# Rezoning Transportation Analysis

Petition Number: 2022-156

Date	Description
02-23-23	First Review (JLP)
03-23-23	Second Review (JLP)

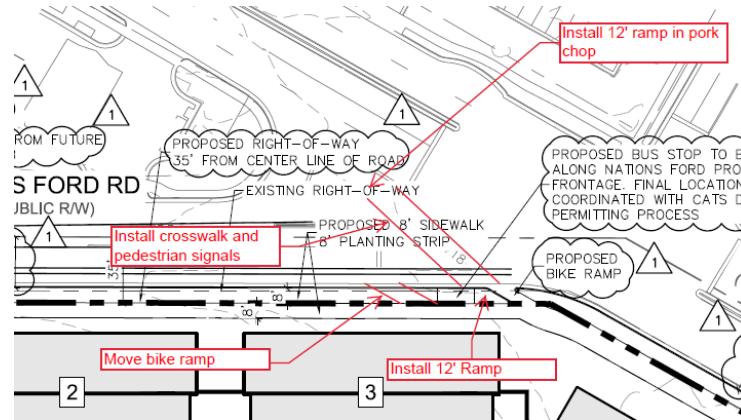
- Revise site plan to dimension the right-of-way and back of curb on South Tryon Street, Nations Ford Road, and Road A.
- ~~Revise site plan and conditional note(s) to commit to construct bicycle facilities on South Tryon Street by installing a 12' multi-use path to meet the Council-adopted Charlotte BIKES Policy. Multi-use paths maintained by the City shall meet ADA/PROWAG requirements.~~
- ~~Revise site plan and conditional note(s) to commit to construct buffered bike lane bicycle facilities on Nations Ford Road by locating the curb and gutter 27' from the center line to meet the Council-adopted Charlotte BIKES Policy. Multi-use paths maintained by the City shall meet ADA/PROWAG requirements. Provide bike ramp along Nations Ford Road near South Tryon Street to transition from the buffered bike lanes to the multi-use path on South Tryon Street.~~

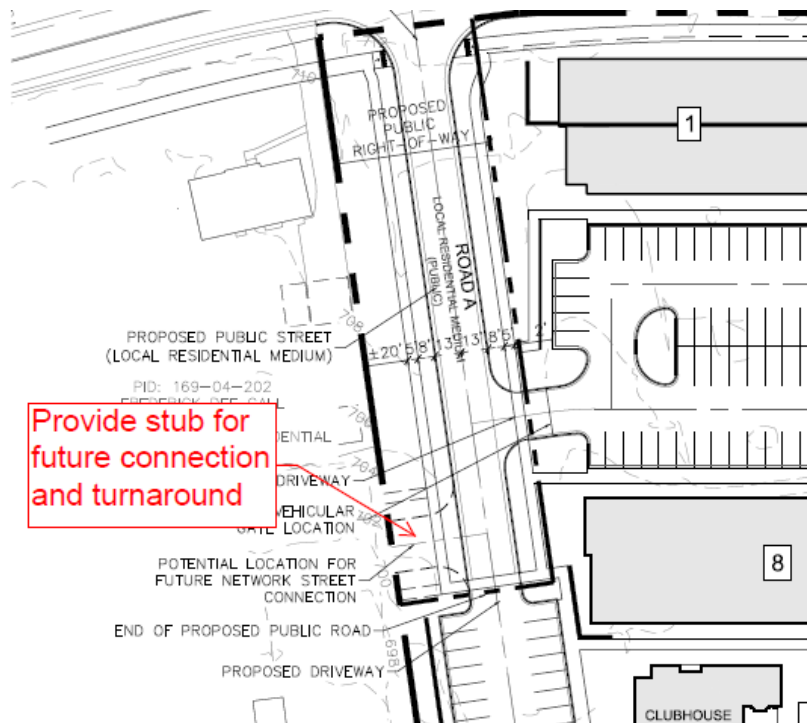
**Clarifying Comment 3/22/23:** Shift bike ramp to precede the pedestrian crossing, extend MUP to new ramp location.

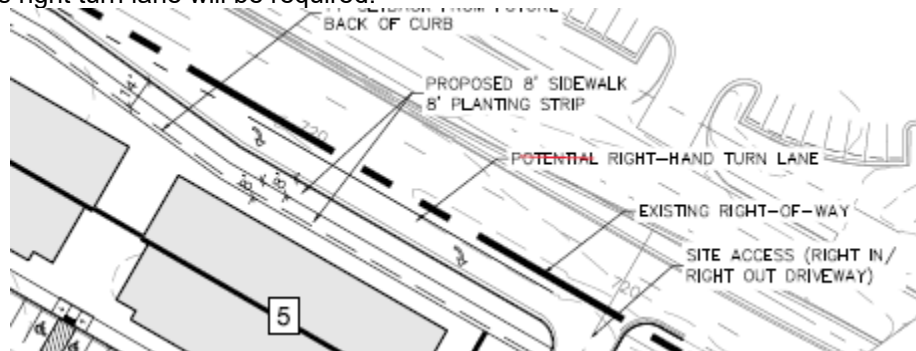
8. ~~Revise site plan and conditional note(s) to relocate the proposed gate a minimum of 40ft from the right of way on Road A~~

Revise potential gate located to  
be a minimum of 40ft from the  
proposed right of way

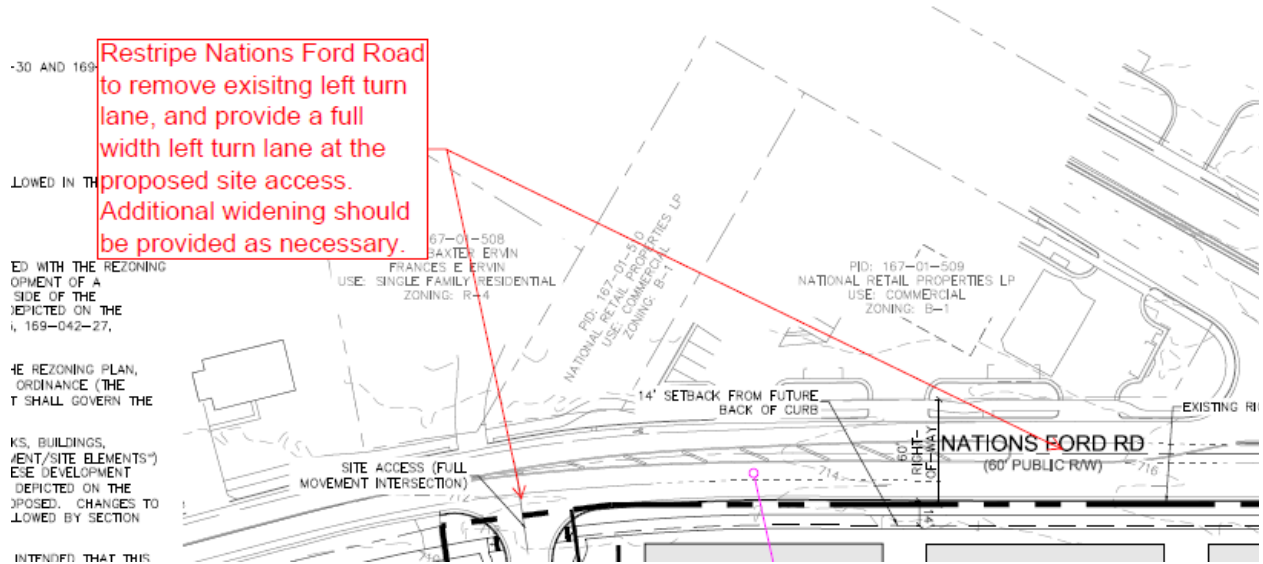
12. ~~Revise site plan and conditional note(s) to commit to restriping Nations Ford Road to remove the existing left turn lane that will not be utilized with the project and provide a full width left turn lane at the proposed site access. Additional widening should be provided to incorporate the left turn lane.~~
